MECKLENBURG COUNTY GROUNDWATER & WASTEWATER SERVICES
APPLICATION FOR A RESIDENTIAL SITE IMPROVEMENT PERMIT/ CONSTRUCTION AUTHORIZATION FOR AN ON-SITE WASTEWATER SYSTEM, NEW WELL INSTALLATION, OR REPAIR OF EXISTING WELL

IMPROVEMENT PERMIT for a RESIDENTIAL ON-SITE WASTEWATER TREATMENT & DISPOSAL SYSTEM

Permit #: **30003170** GWS File #: **6105B** Tax Parcel #: **007-171-30**

SOIL/SITE EVALUATION
for ON-SITE WASTEWATER SYSTEM

Sketch of Soil Evaluation Locations

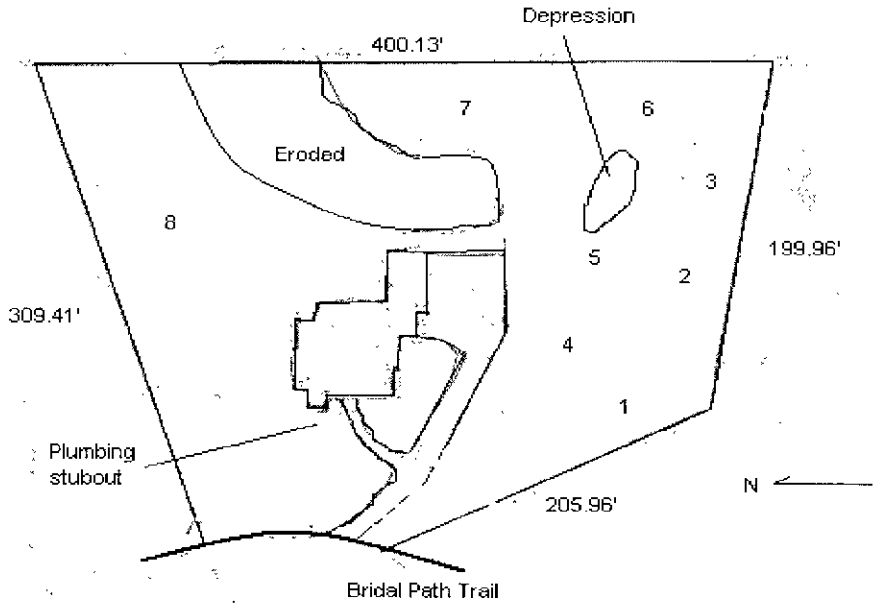
Description	Initial System	Repair System
Available Space (.1945)	PS	PS
System Type(s)	III b	III b
Site LTAR	0.3	0.3

Other Factors (.1946):
Soil Evaluation By: W. R. Marlin, LSS, 1/4/2008,
Others Present:
Site Classification (.1948): PS
Site Evaluation By: Jeremy Michelone, R.S.
Others Present: Kelly Randall, Kimberly Burnett

COMMENTS:
100% repair, house constructed as of 2/4/2008, will need pump

Sketch of Soil Evaluation Locations

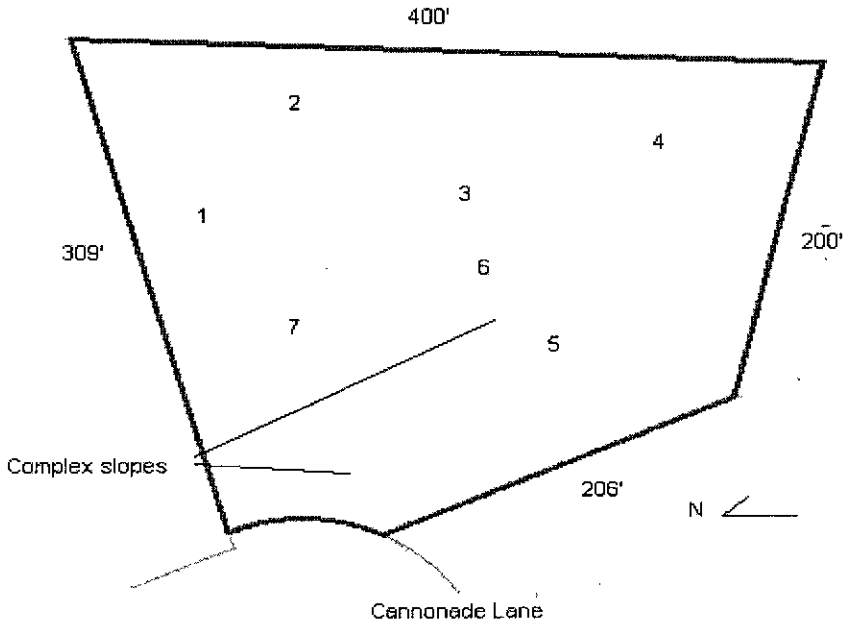
PROFILE #	.1940 Landscape Position/ Slope%	Horizon Depth (IN.)	SOIL MORPHOLOGY .1941		OTHER PROFILE FACTORS				Profile Class & LTAR
			.1941 Structure/ Texture	.1941 Consistence Mineralogy	.1942 Soil Wetness/ Color	.1943 Soil Depth (IN.)	.1956 Sapro Class	.1944 Restr Horiz	
1	LS, 8	0-3	GR/SL	VFR/SEXP/NS/NP	>10" TO SOIL WETNESS	10	N/A	NONE	US
		3-10	ABK/C	VFI/EXP/VS/VP					
2	"	0-5	GR/SL	VFR/SEXP/NS/NP	>13" TO SOIL WETNESS	13	"	"	"
		5-13	ABK/C	VFI/EXP/VS/VP					
3	"	0-4	GR/SL	VFR/SEXP/NS/NP	>11" TO SOIL WETNESS	11	"	"	"
		4-11	ABK/C	VFI/EXP/VS/VP					
4	"	0-5	GR/SL	VFR/SEXP/NS/NP	>48" TO SOIL WETNESS	48	"	"	PS, IV
		5-32	SBK/C	FI/SEXP/S/P					.3GPD/FT^2
		32-48	SBK/CL	FR/SEXP/SS/SP					
5	"	0-6	GR/SCL	"	>41" TO SOIL WETNESS	41	"	"	"
		6-25	SBK/C	FI/SEXP/S/P					
		25-41	SBK/CL	FR/SEXP/SS/SP					
6	"	0-4	GR/SCL	"	>23" TO SOIL WETNESS	23	"	"	US, IV
		4-23	SBK/C	FI/SEXP/S/P					.1GPD/FT^2 LPP
7	"	0-6	GR/SCL	FR/SEXP/SS/SP	>22" TO SOIL WETNESS	22	"	"	US

Description	Initial System	Repair System
Available Space (.1945)	US	US
System Type(s)		
Site LTAR	.3GPD/FT^2	.3GPD/FT^2

Other Factors (.1946):
Site Classification (.1948): UNSUITABLE
Evaluated By: W. R. Marlin, LSS, 9/2/2005, W. R. Marlin
Others Present:

COMMENTS:
100% repair

Based on the criteria set out in Title 15A, Subchapter 18A, of the North Carolina Administrative Code, Rules .1940 through .1948, the evaluation indicated that the site is **UNSUITABLE for** a ground absorption sewage system. Therefore, your request for an improvement permit is **DENIED.** A copy of the site evaluation is enclosed. The site is unsuitable based on the following:

- ☐ Unsuitable soil topography and/or landscape position (Rule .1940)
- ☒ Unsuitable soil characteristics (structure or clay mineralogy) (Rule .1941)
- ☐ Unsuitable soil wetness condition (Rule .1942)
- ☒ Unsuitable soil depth (Rule .1943)
- ☐ Presence of restrictive horizon (Rule .1944)
- ☒ Insufficient space for septic system and repair area (Rule .1945)
- ☐ Unsuitable for meeting required setbacks (Rule .1950)
- ☐ Other (Rule .1946)

The site evaluation included consideration of possible site modifications, and modified, innovative or alternative systems. However, the Health Department has determined that none of the above options will overcome the severe conditions on this site. A possible option might be a system designed to dispose of sewage to another area of suitable soil or off-site to additional property.

However, the site classified as **UNSUITABLE** may be classified as **PROVISIONALLY SUITABLE** if written documentation is provided that meets the requirements of Rule .1948(d). A copy of this rule is enclosed. You may hire a consultant to assist you if you wish to try to develop a plan under which your site could be reclassified as **PROVISIONALLY SUITABLE.**
